RE: DEWEY APARTMENTS

FILE # 65-94(2) TITLE HEADING: Final Plan/Plat - Dewey Apts.

Title: DEWEY APARTMENTS, Final Plat and Plan

FILE: #65-94(2)
DATE: August 15, 1994
STAFF: Kathy Portner
REQUEST: Final Plan for a duplex
LOCATION: 2845 Texas Avenue
APPLICANT: Dewey Family Trust

GRADING PLAN DRAINAGE EXHIBIT

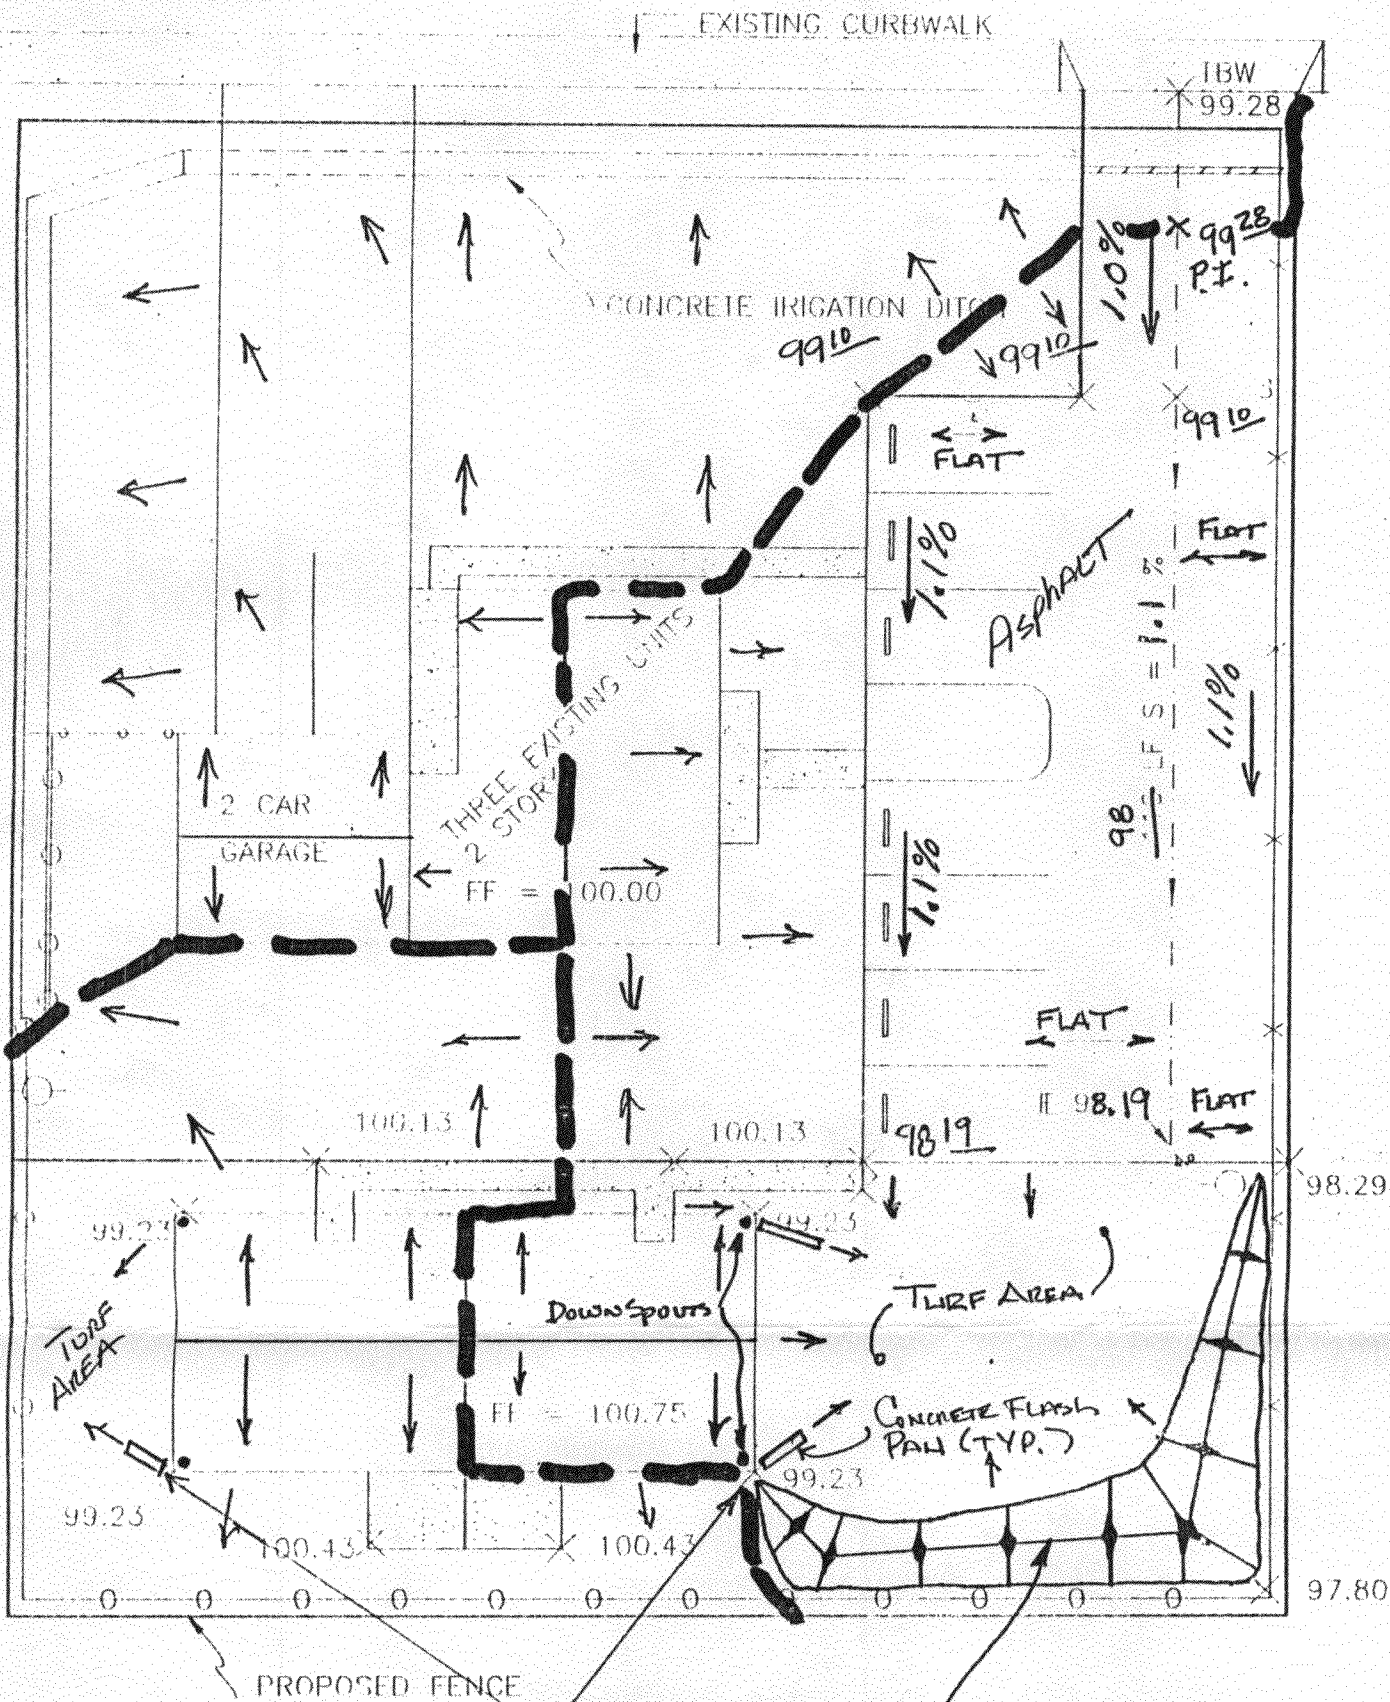
Transportation Capacity Payment of \$800 will be required.
City curb cut permit required for new driveway.
Drainage as shown is not acceptable. You may not discharge more than historic rate to private property. Need to detain/retain 100 year runoff on site.

1. Surveyor's certification must include a statement that the plat conforms with all applicable provisions of the City Zoning and Development Code (SSID, IX-15, 1.)
2. In the dedication statement for utility easements, "non-exclusive" must be deleted.
3. Parks and Open Space fee of \$225 per unit for the new units will be due.
4. Is the petitioner proposing a drainage fee be paid in lieu of on-site detention?
5. The 6' high privacy fence must extend along the east property line between the parking area and the adjacent property. In the area of the front yard setback from Texas Avenue the 6' fence must be reduced in height to a maximum of 30". A separate fence permit will be required for the fence.
6. It's not clear how the 20' rear yard setback interferes with an overhead power line for which no easement is shown.

Please find attached a "Drainage Exhibit" showing the proposed drainage improvements associated with construction of the multifamily residence and associated parking area.

In keeping with our meeting of 09/07/94 we are proposing that the stormwater runoff generated as a result of development be attenuated in the following manner.

1. The proposed asphalt parking area be graded at 1.1 %, sloping away from Texas avenue south towards a proposed "turf area" low point just east of the new structure. The parking area shall not have a cross slope thus promoting sheet flow for even distribution of runoff to the turfed area.
2. The "turf area" low point shall be formed and bounded by the construction of a landscape and drainage control berm. The construction of this berm will collect runoff from the east one-half of the new structure and the new parking area. This should effectively cut-off flow towards property south of the project.
3. Roof gutters and down spots should be installed in such a manner as to direct runoff towards turf areas and the "low area" as shown on the drainage exhibit. The down spots should not be oriented to direct runoff directly south.

The turf areas are to act as absorption field for storm runoff. For that reason it is important that the appropriate ground cover be installed as indicated.

DIRECT ROOF DRAINAGE TO LOW "TURF AREA" FROM DOWNSPOUTS AND RAIN GUTTERS.

DRAINAGE CONTROL AND LANDSCAPE BERM. TOP OF BERM EL. = 100.20 MIN.
